**SAIB:** CE-10-08

**SUBJ:** Wings: Zodiac CH601XL and CH650 Wing Structural Modifications     **Date:** November 7, 2009

**SAFETY ALERT / SAFETY DIRECTIVE**

<b>ZODIAC</b> CH 601 XL / 650	UPGRADE DRAWINGS WING SPAR & REAR CHANNEL	<b>6-ZU-1</b>
<small>Copyright© 2009 CHRIS HEINTZ</small>		<small>DATE: 25 JAN 2010</small>

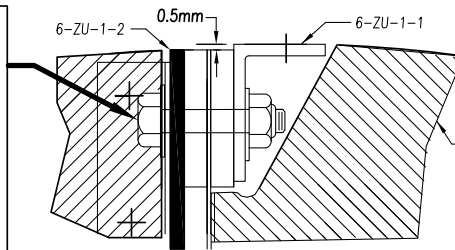
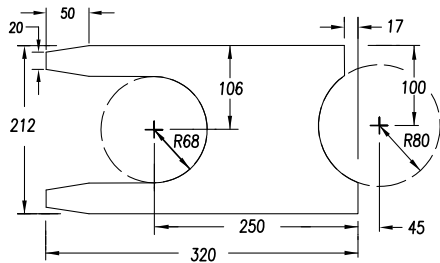
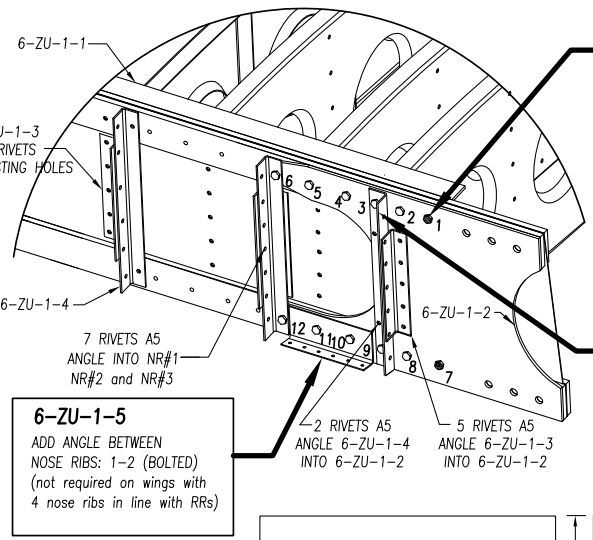
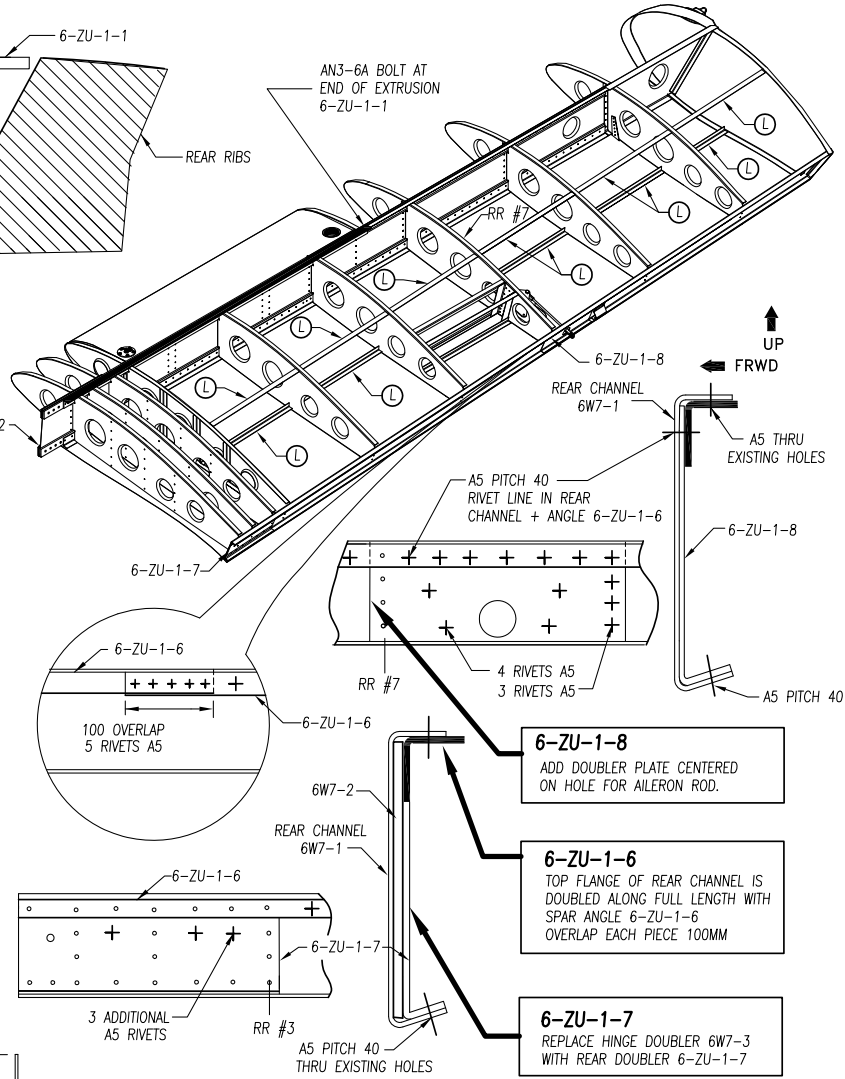
DRILL OUT SOLID RIVETS.  
 CUT SPAR ANGLE 6W3-6 AT 1680MM FROM INBOARD END.  
 TRIM BACK TOP FLANGE ON REAR RIBS TO CLEAR 6-ZU-1-1.  
 INSTALL EXTRUSION WITH SOLID RIVETS MS20470AD-6-14 AND  
 MS20470AD-6-15 (QTY=4) MS20470AD-6-10  
 USE BOLTS IN ROOT AREA 6-ZU-1-2 AND ONE BOLT IN LIEU OF  
 RIVET AT OUTBOARD END OF EXTRUSION.

DRILL OR REAM ALL BOLT HOLES TO ENSURE CLOSE TOLERANCE  
 FIT OF BOLTS IN HOLES. IT IS ACCEPTABLE TO REPLACE  
 SOLID RIVETS BY AIRFRAME BOLTS OF EQUAL DIAMETER.

**6-ZU-1-3**  
 REPLACE 6W3-9 WITH 6-ZU-1-3.  
 TRIM 1/8" OFF END OF NOSE RIB#1 AND 2  
 RIB SANDWICHED BETWEEN 6-ZU-1-3  
 AND 6-ZU-1-4. RIVET TO SIDE OF RIB

REMOVE NOSE RIB #1, #2 and #3. DRILL  
 OUT BOTTOM SOLID RIVETS TO ADD  
 6-ZU-1-2 ON FRONT SIDE OF SPAR.

**6-ZU-1-5**  
 ADD ANGLE BETWEEN  
 NOSE RIBS: 1-2 (BOLTED)  
 (not required on wings with  
 4 nose ribs in line with RRs)

**6-ZU-1-4**  
 TRIM 1/8" OFF BACK OF NR#1  
 ADD .040" ANGLE TO REPLACE 6W3-9

**6-ZU-1-8**  
 ADD DOUBLER PLATE CENTERED  
 ON HOLE FOR AILERON ROD.

**6-ZU-1-6**  
 TOP FLANGE OF REAR CHANNEL IS  
 DOUBLED ALONG FULL LENGTH WITH  
 SPAR ANGLE 6-ZU-1-6  
 OVERLAP EACH PIECE 100MM

**6-ZU-1-7**  
 REPLACE HINGE DOUBLER 6W7-3  
 WITH REAR DOUBLER 6-ZU-1-7

UPGRADE DRAWINGS  
CENTER SPAR SECTION

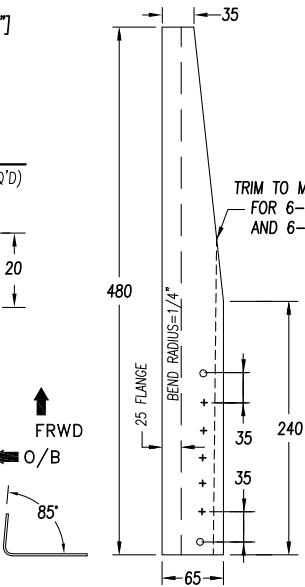
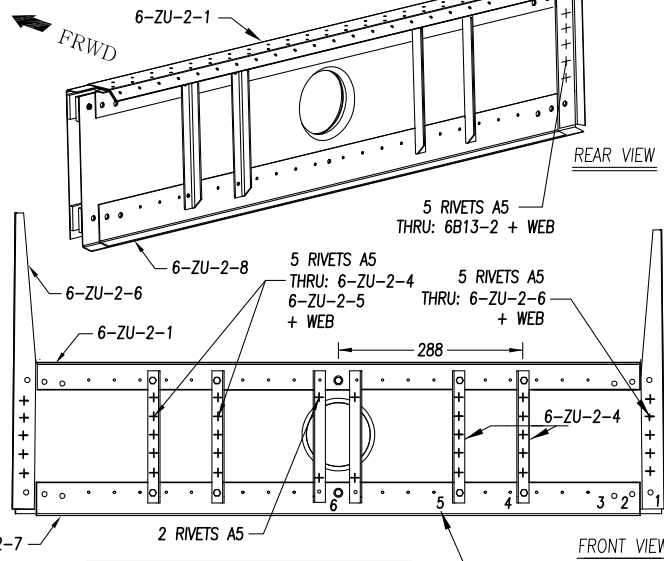
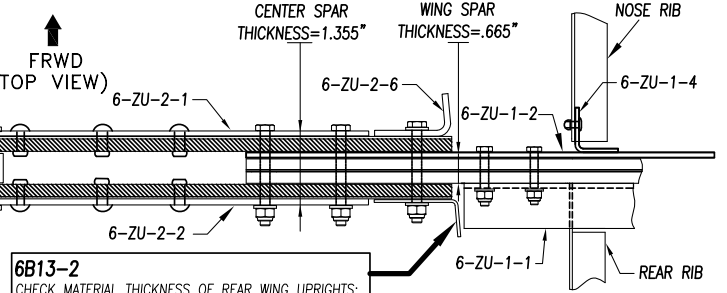
FIRST SOLID RIVET 6-ZU-2-7 AND 6-ZU-2-8 TO CAPS, ADD A FLAT PENNY WASHER AN970-4 ON EACH SIDE OF EXISTING SPACERS 6W4-5 ADD WEB SPACER 6-ZU-2-3. AND RE-ASSEMBLE WITH LONGER BOLTS.

REPLACE FRONT UPRIGHT. DRILL NEW HOLES IN FUSELAGE SIDE SKIN INTO UPRIGHT DOUBLER 6-ZU-3-5 (IGNORE EXISTING HOLES).

6B13-2  
CHECK MATERIAL THICKNESS OF REAR WING UPRIGHTS:  
IF t=.040" REPLACE WITH t=.063"

DRILL OUT SOLID RIVETS ADD DOUBLER ON TOP OF SPAR. RE-ASSEMBLE WITH SOLID RIVETS.  
MS20470AD-5-10

UPRIGHTS OVERLAP ON TOP OF DOUBLERS INSTALLED WITH BOLTS THRU SPACER 6-ZU-2-3 RE-INSTALL UPRIGHTS 6W4-4 WITH SOLID RIVETS MS20470AD-5-11

ADD A SHIM BETWEEN WEB AND UPRIGHT. TRIM LENGTH TO FIT BETWEEN TOP DOUBLER AND BOTTOM ANGLE. RIVET UPRIGHT TO WEB.

DRILL OUT SOLID RIVETS. OVERLAP ANGLE ON FRONT SIDE OF WEB AND FLANGE. SOLID RIVET SPAR ASSEMBLY.

DRILL OUT SOLID RIVETS ADD DOUBLER ON BACK SIDE IN TOP CORNER. ASSEMBLE WITH SOLID RIVETS.

DRILL OUT SOLID RIVETS ADD ANGLE ON TOP OF WEB AND BOTTOM FLANGE. SOLID RIVET SPAR ASSEMBLY.

OVERLAP ON OUTSIDE OF FUSELAGE. REAR RIVET LINE THRU EXISTING HOLES NEW RIVET LINE THRU 6-ZU-2-7. ADD FRONT RIVET LINE

UPGRADE DRAWINGS  
BELLCRANK CHANNEL - DOUBLERS

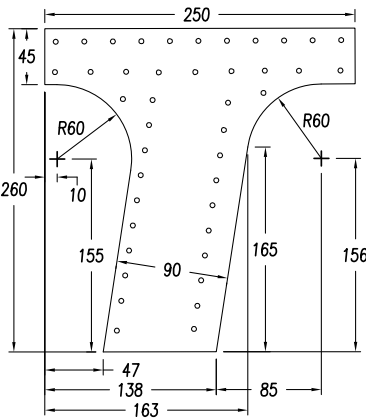
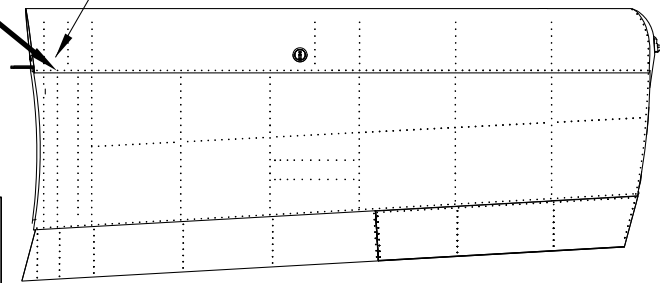
REPLACE L ANGLES ALONG SIDES OF ACCESS HOLE IN SEAT PANEL 6B15-4 WITH LONGER ANGLES 6-ZU-3-4 ALSO ADD AN ANGLE 6-ZU-3-4 IN CORNER OF SEAT PANEL AND ARM REST SIDE 6B18-1

XL ONLY - REPLACE REAR WING ATTACH PLATE 6B5-4 WITH THICKER MATERIAL 6-ZU-3-3

UPRIGHT DOUBLER OVERLAPS ON OUTSIDE OF FUSELAGE SIDE SKINS. AFT RIVET LINE THRU EXISTING UPRIGHT 6B13-2, FRONT RIVET LINE THRU 6-ZU-2-6

ADD DIAGONAL STANDARD Z ANGLE TO FUSELAGE SIDE SKIN - FROM FRONT BOTTOM OF SPAR TO TOP CORNER OF VERTICAL L ANGLE AND LONGERON.

ADD L ANGLES BETWEEN REAR RIBS. ENDS RIVETED TO FLANGES OF BELLCRANK CHANNEL 6-ZU-3-1 RIVETED TO TOP AND BOTTOM SKINS. VIEW FRONT TOP OF RIGHT WING

ADD FUSELAGE SIDE DOUBLER OVERLAPS OUTBOARD FLANGE OF GUSSET 6B10-4 RE-USE AN3-5A WITH 1 WASHER REF. DRAWING 6-B-14

DOUBLE UP RIVET LINE THRU SPAR EXTRUSION [TOP] AND SPAR ANGLE [BOTTOM] UP TO RR # 5

REPLACE BELLCRANK SUPPORT CHANNEL 6W6-10 BY 6-ZU-3-1 REINSTALL BELLCRANK SUPPORT 6W6-11 PER DRAWINGS 6-W-6

UPGRADE DRAWINGS  
 CONTROL STOPS - SERVO L ANGLES

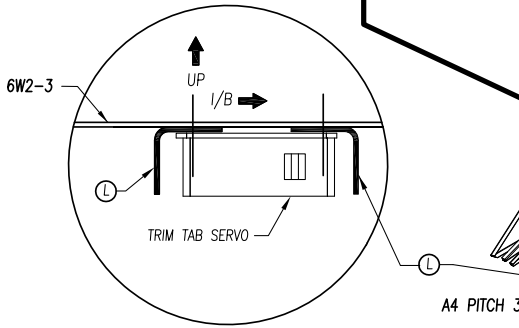
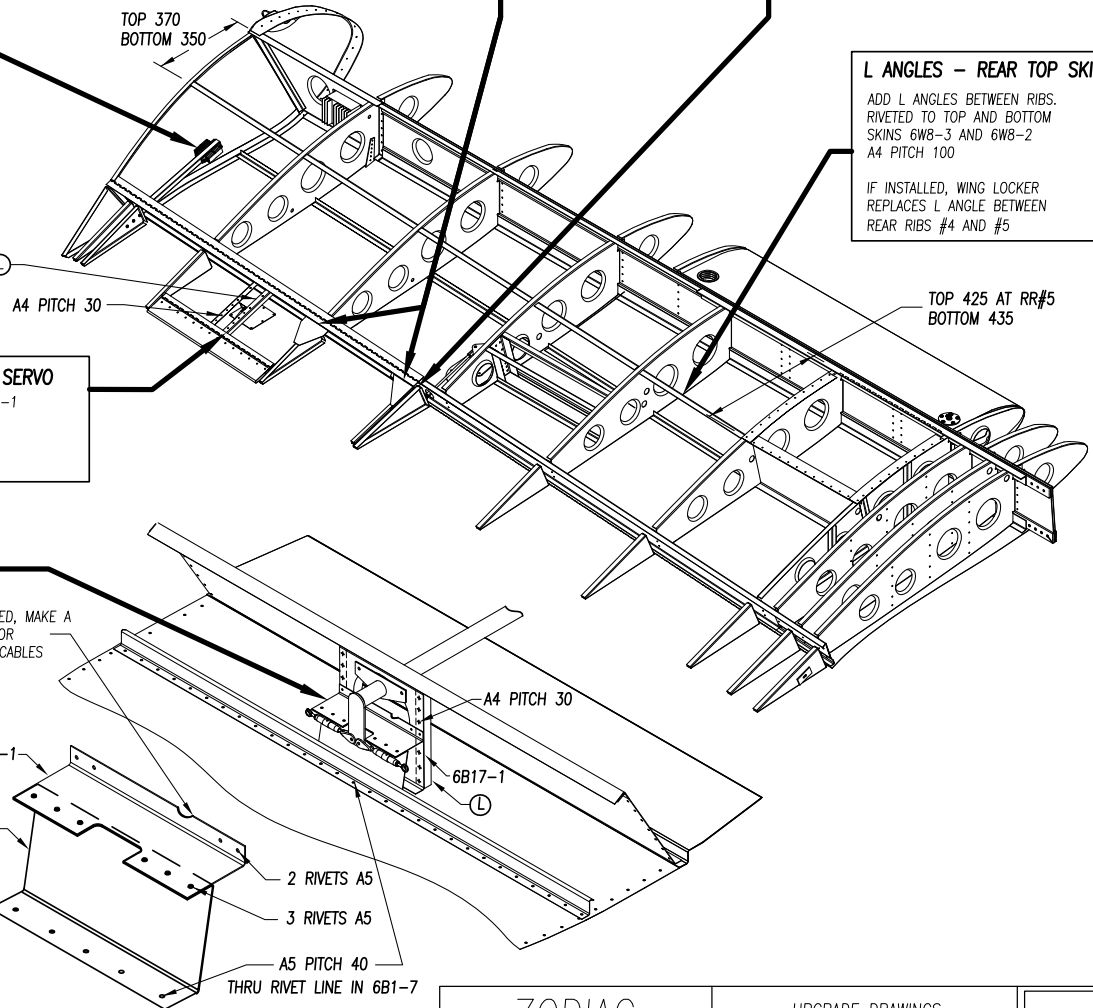
BALANCED AILERON see LAA/MOD/162B/004  
 INSTALL BALANCE ARM TO AILERON RIBS  
 WITH AN3-11A BOLTS AND AN365-1032 NUTS  
 AILERON MASS BALANCE ALSO TO BE INSTALLED ON  
 AILERONS WITH FLEX HINGE 6W2-3

REF. AILERON TRIM TAB OPTION 6-ATO-1  
 ADD L ANGLES BETWEEN SERVO AND  
 AILERON SKIN 6W2-3 OR 6-PH-1-1  
 LENGTH=265

AILERON CONTROL STOP.  
 FILE CUTOUT TO INCREASE DEFLECTION  
 AS NECESSARY.

ADD AN L ANGLE TO SIDES OF  
 REAR TORQUE TUBE BEARING  
 SUPPORT 6B17-1

GUSSETS BETWEEN SKIN AND RIB  
 65W2-5 AILERON RIB #2 GUSSET  
 65W2-6 AILERON RIB #1 GUSSET

ELECTRIC FLAP ACTUATOR DRAWS FLAPS UP AGAINST  
 FLAP STOPS AND SHUTS OFF AUTOMATICALLY WITH  
 FLAPS UNDER LOAD. WHEN ONE FLAP IS COMPRESSED  
 AGAINST ITS FLAP STOP, CHECK THAT OTHER FLAP IS  
 ALSO PUSHED FIRMLY AGAINST ITS STOP.  
 REPLACE ONE STOP IF NECESSARY.

ADD L ANGLES BETWEEN RIBS.  
 RIVETED TO TOP AND BOTTOM  
 SKINS 6W8-3 AND 6W8-2  
 A4 PITCH 100
